COMMENT RESPONSE DOCUMENT

EASA PAD No. 20-146

[Published on 25 September 2020 and officially closed for comments on 23 October 2020]

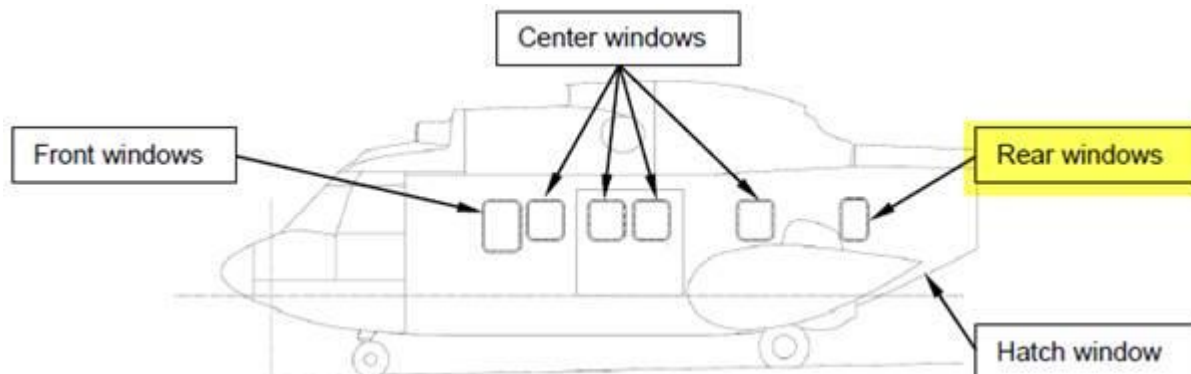
Based on customer requirement, to have an escape possibility thru the rear cabin window, have our AS332L/L1 fleet been modified with enlarged cabin windows at rear of cabin, both L/H and R/H side.

This modification is based on Bristow Helicopters Ltd. MOD/332/53.4698 that have been approved by CAA-N, see attached approval letter.

CHC Helikopter Service request that the coming AD give possibility to keep the pop-out function on the enlarged rear cabin windows on the AS332L/L1, based on the Norog 066 requirement, even that the opening does not fulfil the minimum measurements of 356 mm width and in SPA.HOFO.165(h).

We disagree with the suggested amendment of the final AD. In case existing modifications or repairs to a helicopter make compliance with AD difficult or impossible, the operator/owner may choose to apply for an alternative method of compliance (AMOC) to comply with the AD (EASA form FO.CAP.00042).

Airbus Helicopter modifications introduced by AS332-56-00-18 and ASB AS332-56-00-21 were not designed for enlarged windows implemented by Bristow Helicopters Ltd. MOD/332/53.4698 and therefore CHC Helikopter Service may want to develop and propose an alternative technical solution, get it approved and, concurrently, or consequently, apply for an AMOC.
